Battery Cable Mounting Clamp
CHU, CXU, GU, LEU, MRU, TD

FSB 371-044, Battery Cable Mounting Clamps

(January 2013)

W2079310

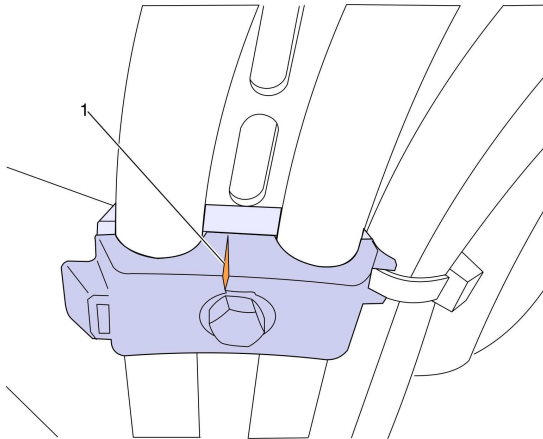
- 1 Disconnect all of the positive and negative battery cables from the batteries.
- 2 Locate the cracked or broken battery cable clamps.

1. Cracked or broken clamp

W2079311

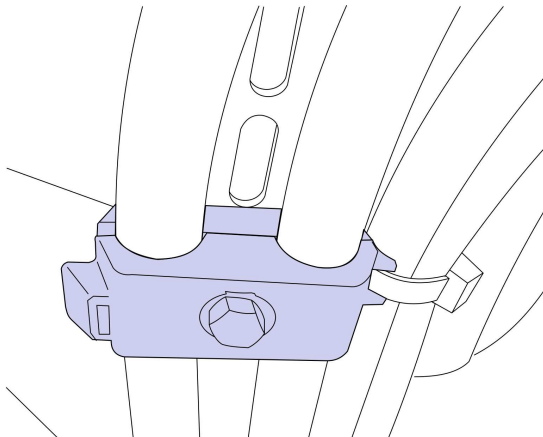
- 3 Remove the clamp from the bracket mount and cables.
- 4 Install new clamp part # 21658909 onto the cable and secure bracket mounting. Replace cable ties as required.

Torque the nut to: 8.1 ± 1.4 Nm (6 ± 1 ft-lb)

Note: Ensure new clamp is positioned correctly before snapping together otherwise repositioning may be difficult.
